RE: Title 19 complaint about the construction of the Mui Ho Fine Arts Library in Rand Hall, Cornell University, Ithaca, NY

Based on information contained in Drawings LSP-100 – LSP-103 prepared by STV Architects, dated Feb. 14, 2018, and an Atrium Smoke Control Report prepared by GHD, Inc., dated August 2017, I believe that the Mui Ho Fine Arts Library at Cornell University has numerous New York State Building Code violations. Code sections referenced below are from the [2015 New York State Building Code](#) unless otherwise noted.

Figure 1. (a) View, from left to right, of interconnected Sibley, Milstein, and Rand Hall; and (b) second-floor plan showing net second-floor areas of Milstein, E. Sibley, and Rand Halls.

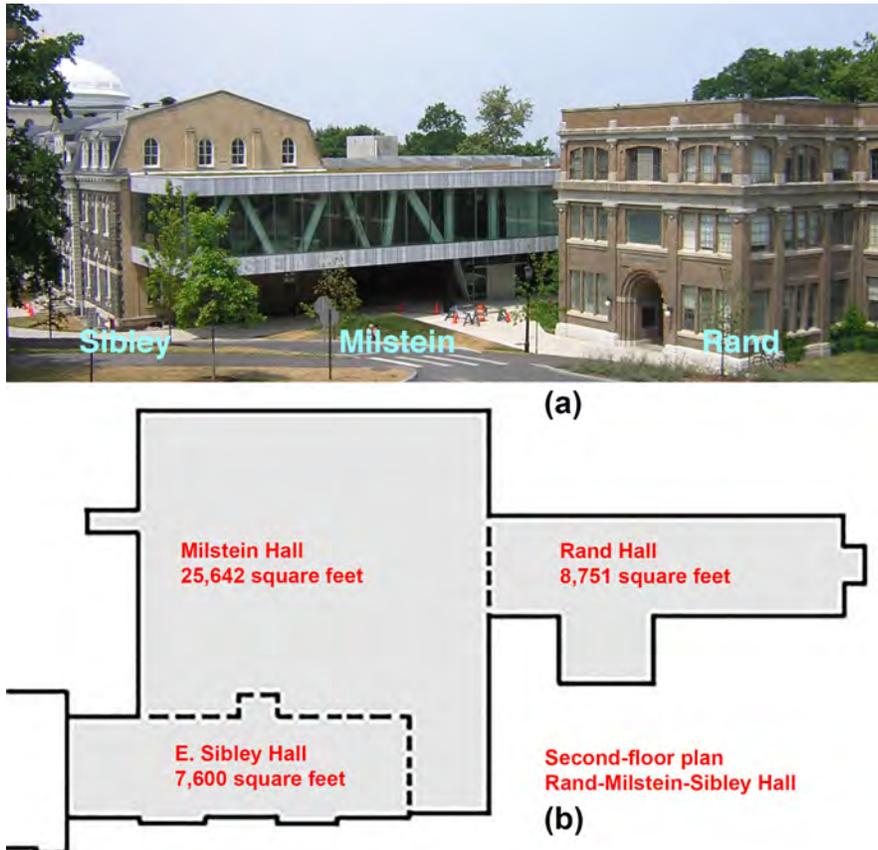
Before being connected to Milstein Hall in 2011, Rand Hall was a 3-story Type IIB non-fireproofed steel frame building and E. Sibley Hall was a 3-story Type VB building (with non-fireproofed wood exterior bearing walls at the third floor). Since the two buildings were connected to 2-story Milstein Hall without fire walls (Figure 1), Rand-Milstein-Sibley Hall became a *single building* with Type VB construction.

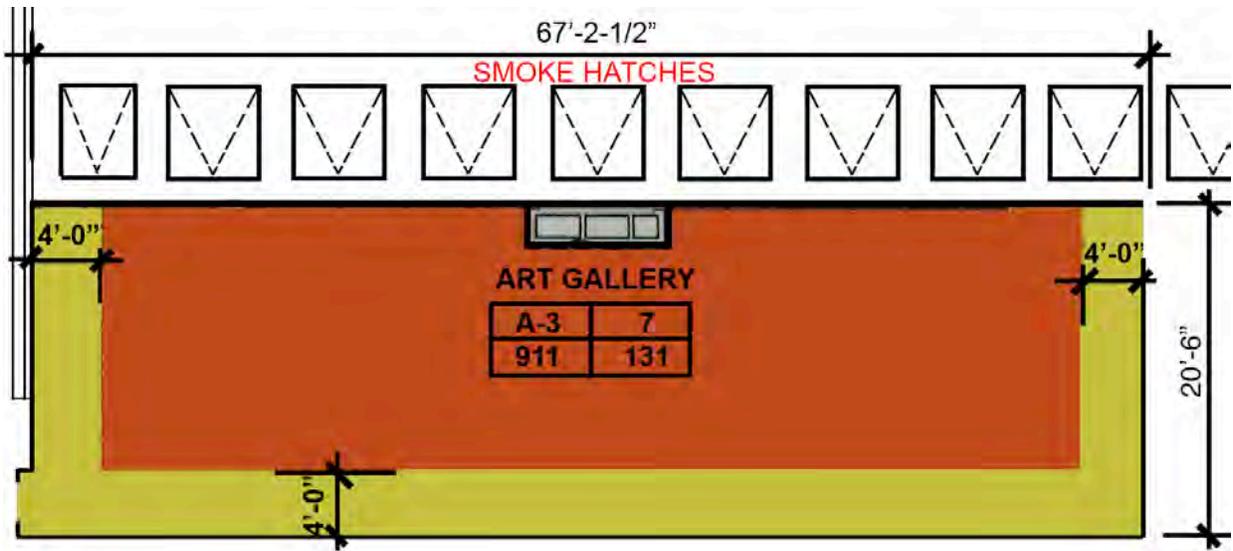
Explanation: The stated occupancy for the roof-top art gallery of 131 is found by using an incorrect gallery area of 911 square feet and an incorrect occupant load factor of 7 square feet per occupant (Figure 2). The actual occupancy is 263, based on an actual area of $67'-2\frac{1}{2}" \times 20'-6" = 1,315$ net square feet and an occupant load factor of 5. In this calculation, I have computed the gallery area by first subtracting 6 inches from the circulation zone edges and then subtracting 20 square feet for a utility enclosure on the north side of the gallery. This actual area includes the hypothetical egress pathways at the perimeter of the gallery space that are colored yellow on the architect's plans, sheet LSP-103, apparently (and deceptively) to imply that they might represent something literally separated from the orange-colored main gallery space (Figure 2). In fact, the entire *actual* gallery area—i.e., both the orange and yellow zones drawn by the architects—must be accounted for when computing the occupancy of the space.

The architects inappropriately *subtracted* this yellow colored circulation pathway area from the actual gallery area and used the incorrect load factor of 7 to compute the fictitious values shown on sheet LSP-103, and reproduced in Figure 2, i.e., 911 square feet for the art gallery area and $911/7 = 131$ occupants.

Note that the correct occupant load factor of 5 is for "standing space" (corresponding to the actual use of the space, and consistent with the occupant load factor used, for example, in the nearby Milstein Hall art gallery) whereas the occupant load factor of 7 is for "chairs only—not fixed" a factor which does not represent the actual use of the roof-top space (see Table 1004.1.2 reproduced in Figure 3).

Figure 5. Schematic section through the fifth-story roof-top enclosed spaces and atrium. (Drawn by Jonathan Ochshorn)

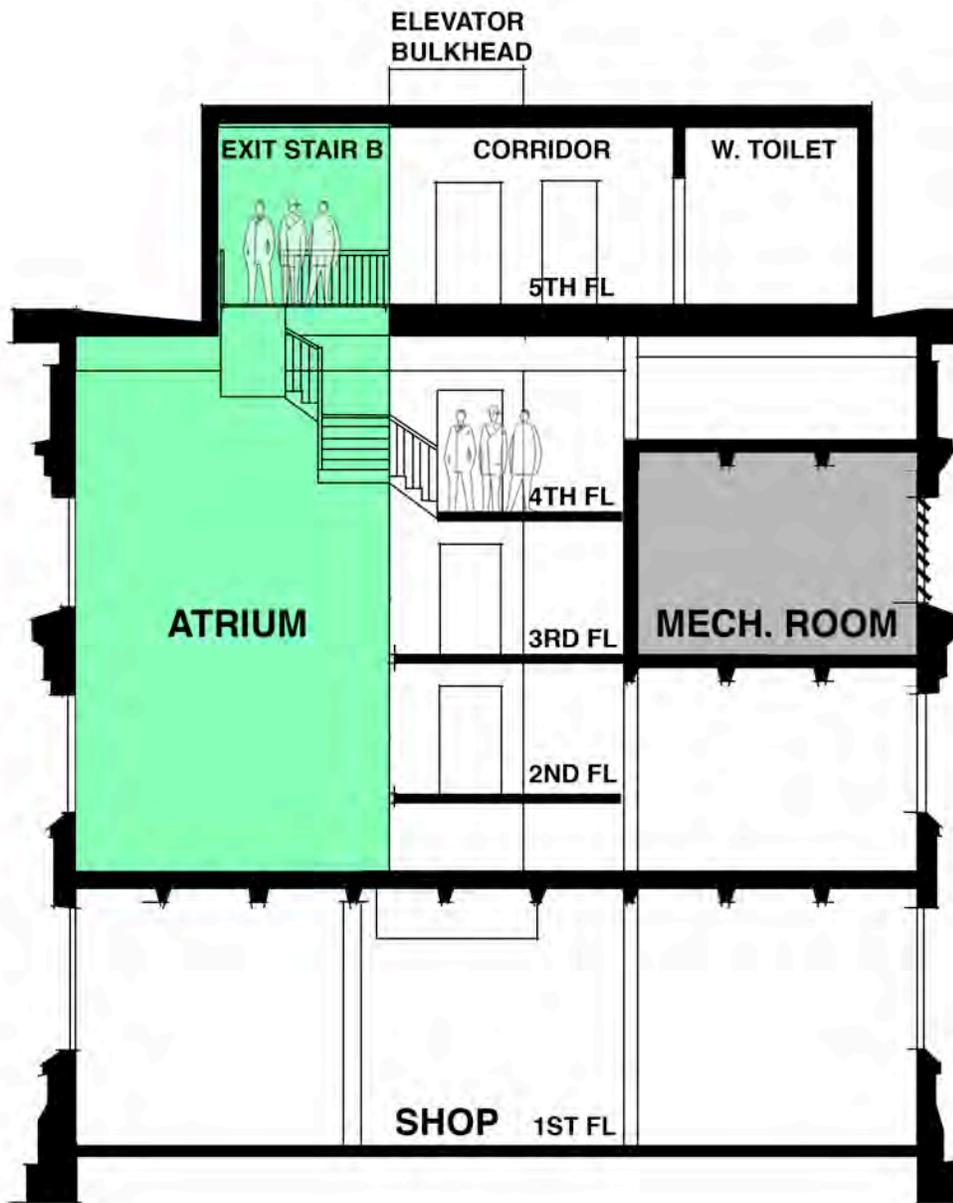
A schematic section through the roof-top enclosed space is shown in Figure 5. This section clearly shows that there are no double height spaces in the fourth story within which a mezzanine could be placed. In other words, the architects are inappropriately using the *atrium* area to demonstrate conformance with Section 505.2.1, rather than using an area within a fourth-floor room or space as the section requires. Both Figures 4 and 5 show that the story incorrectly labeled “mezzanine” (bounded by a black line in Figure 4) is only marginally *above* any fourth-floor room or space (bounded by a red line), and is not *between* the floor and ceiling of any fourth-floor room or space, as required by the code. The fourth story below the enclosed roof-top spaces is little more than a corridor, while the greater part of the enclosed roof-top spaces are directly above—not the fourth floor—but rather the ceiling of a third-story mechanical room. The exit access stairway (“Exit Stair B”) connecting the fifth-story roof-top spaces to the fourth story is *in the atrium*, not in any mezzanine, as can be clearly seen in Figure 5.

By incorrectly defining the mezzanine as being within the atrium, the architects have unwittingly confirmed that it is the *atrium*, and not some fictitious mezzanine, that actually extends above the fourth-floor level in order to provide access to a roof-top story containing toilet rooms and an elevator, both of which have been made necessary by the addition of a roof-top art gallery with 263 occupants.

There are two immediate code violations that follow logically from the mis-labeling of the fifth story as a mezzanine within the fourth story. First, the part of the atrium that extends into the fifth story must be separated from the enclosed roof-top spaces with 1-hour fire barriers, since only three floors can be open to the atrium per Section 404.6, exception 3. Second, as explained in Violation #7, the entire building must be built with Type I construction, rather than with Type IIB or Type IIA construction.

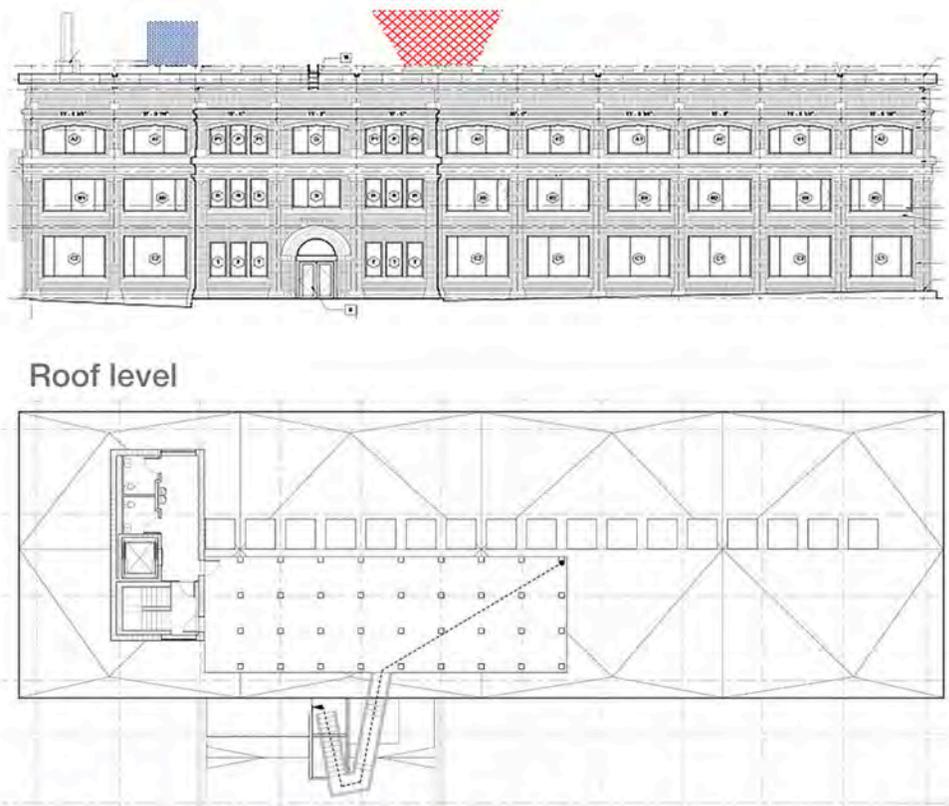
While the fifth story is itself small—containing only bathrooms, an elevator, and a corridor—it provides access to a new unenclosed roof-top art gallery with 263 occupants, greatly increasing the total library occupancy compared to any of the prior versions for which variances were granted. It is also relevant to consider Cornell’s intentions for the outdoor roof-top art gallery, advertised on their website for the Mui Ho Fine Arts Library as well as in an exhibit in November 2017 called “Full Scale.” Cornell’s intention, [made explicit in this exhibit](#) and reinforced on the [library homepage](#) (reproduced in Figure 6) is that “every few years a new team of students builds a [roof-top] classroom as part of the ongoing research and collaboration in physical making that Cornell is so proud of, as Buckminster Fuller once built one of his geometric domes on the very same roof almost 70 years ago.”

Pavilions, even if temporary (i.e., “erected for a period of less than 180 days”), still need to follow the requirements outlined in Section 3103, including conforming “to the structural strength, fire safety, means of egress, accessibility, light, ventilation and sanitary requirements of this code as necessary to ensure public health, safety and general welfare.” In any case, whether “temporary” or exceeding the 180-day time limit, such covered structures would count as part of a fifth-story, since they are *on top of* the roof, and could not possibly be designated as mezzanines *between* the floor and ceiling of the fourth story below, as the definition of a mezzanine in Chapter 2 of the code requires. The current scheme, in fact, contains sprinkler and utility hook-ups *at the roof level* in anticipation of these future enclosed pavilions. For this reason, a designation of the current fifth-story bathrooms, corridor, and elevator as a mezzanine within the fourth story is not only improper on its own merits, but by implicitly suggesting that the intended future roof-top pavilions will also count as fourth-story mezzanines, Cornell is effectively inviting the Ithaca Building Department to acknowledge and agree, in advance, to that noncompliant vision.

Figure 7. Schematic section through atrium showing how the smoke layer would migrate to the highest point of the atrium, directly in the path of egress from the roof-top art gallery through Exit Stair "B"

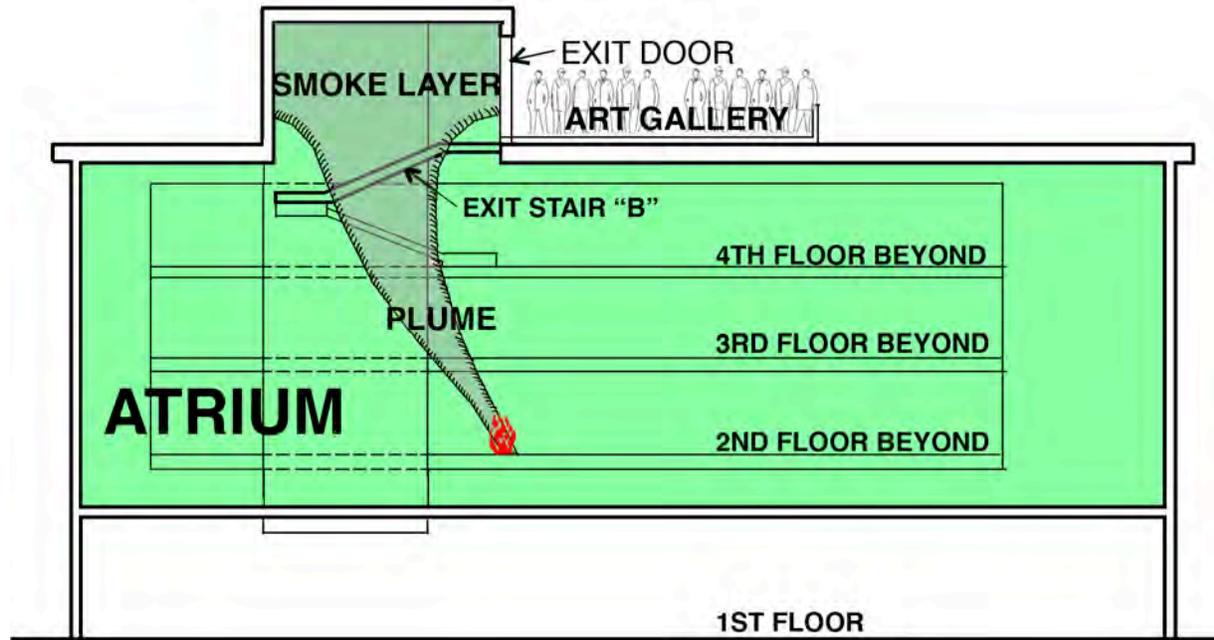
In addition to providing a 1-hour horizontal assembly between the atrium and the roof gallery, the part of the atrium that extends into the fifth story (see Figure 7 below) must also be separated from the adjacent outdoor roof gallery by a 1-hour fire barrier.

Explanation: Section 909.1 requires that the atrium smoke control system “provide a tenable environment for the evacuation or relocation of occupants.” The smoke exhaust system not only does *not* “provide a tenable environment” for emergency egress, but actually places occupants attempting to egress from the roof-top gallery directly in the path of toxic smoke and other exhaust products. This happens in two ways. First, many of the roof-top atrium smoke hatches are immediately adjacent to the occupied roof-top art gallery (see Figure 2 and Figure 8), so that smoke being exhausted through these hatches could blow directly onto roof-top occupants. Second, since the atrium extends into the fifth floor (Figure 7), it will act as a primary smoke exhaust vent when the exit door from the roof-top art gallery is opened,

even though this door is not labeled, or intended, as an exhaust vent. This smoke control system is entirely passive, with no mechanical exhaust; as a result, art gallery occupants attempting to exit through Exit Stair B will likely encounter toxic smoke emerging from the exit door, which is at the highest point in the atrium and therefore the most likely location for the hot smoke layer to migrate.

Figure 8. Schematic section through atrium illustrating scenario with fire location at north side of building that was not modeled in the smoke control report prepared for Cornell by GHD

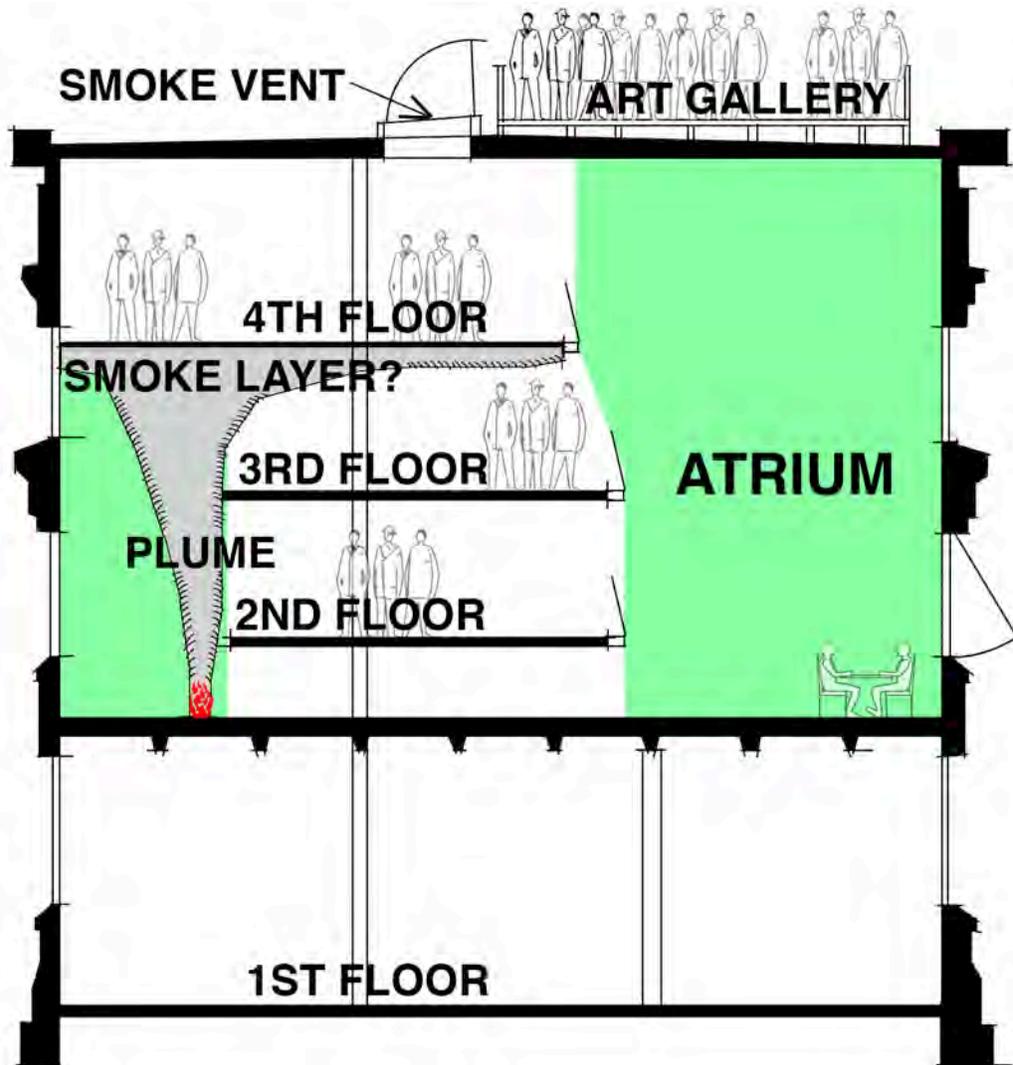
What the atrium smoke control report also doesn't model is a fire location at the *north* side of the book stacks (Figure 8). This is important because the fourth floor extends all the way to the exterior wall on the north side, thereby potentially blocking movement of smoke into the smoke vents at the atrium roof.

The smoke control report also does not mention whether the specific building geometry developed for the fire/smoke model takes into account the perforated (i.e., open) floor gratings and six-inch “flue space” under the bookstacks at each floor level. In fact, the requirements of Building Code Section 909.2—that documents must “include sufficient information and detail to adequately describe the elements of the design necessary for the proper implementation of the smoke control systems [and that] these documents shall be accompanied by sufficient information and analysis to demonstrate compliance with these provisions”—is not met, since much crucial information is missing, including the following:
